**From:** [REDACTED]  
**Sent:** Thursday, September 14, 2023 10:10 AM  
**To:** Jennifer Armer <[JArmer@losgatosca.gov](mailto:JArmer@losgatosca.gov)>  
**Cc:** 'Eric Hulser' [REDACTED]  
**Subject:** RE: 15860 Winchester Boulevard - Note to Town Council

Re: 15860 Winchester Boulevard  
Architecture and Site Application S-21-008,  
Conditional Use Permit Application U-21-010,  
Variance Application V-21-003,  
Subdivision Application M-22-008, and  
Mitigated Negative Declaration ND-22-001d

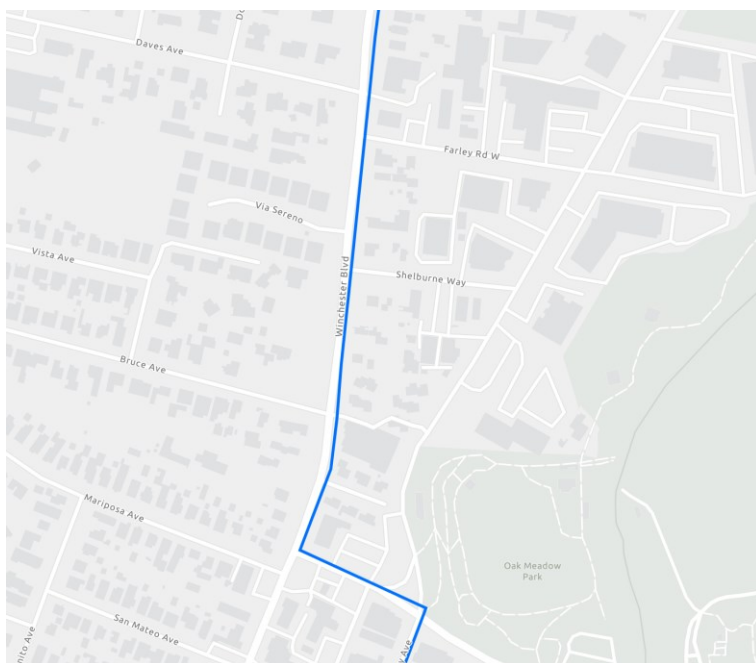
First, please note that the findings by Staff are based on outdated and stale plans. Please refer to all dates in the documents, plans and reports. For example, the Winchester Memory Care Assisted Living sheets are dated April 1, 2021 and the Existing Conditions are dated November 1, 2021.

The letters from the Applicant are dated from December 13, 2021 and the latest revision date is August 2, 2022. The conditions and statements in the letters should be current, not stale (e.g., traffic conditions, bicycle conditions, neighborhood outreach and communications, etc).

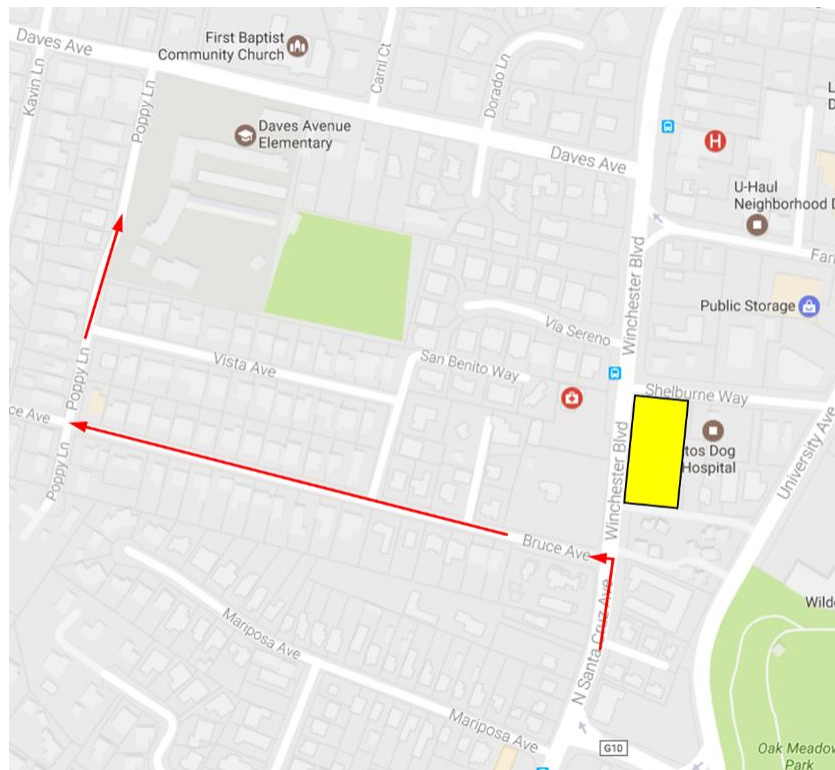
The major gap in the analysis was understanding the traffic flows generated by Daves Avenue Elementary School. The traffic flows at the T intersection of Bruce Avenue and Winchester Boulevard, just steps South and across the street from the proposed development were not identified whatsoever in the analysis (see diagram below, taken from Figure 1 Site Locations and Study Intersections).

Although the Town of Los Gatos specifically requested that the impact on Daves Avenue be considered in the transportation impact analysis, the intent was probably to understand the impact on drop-off and pick-up at Daves Avenue Elementary School. The report included the following:
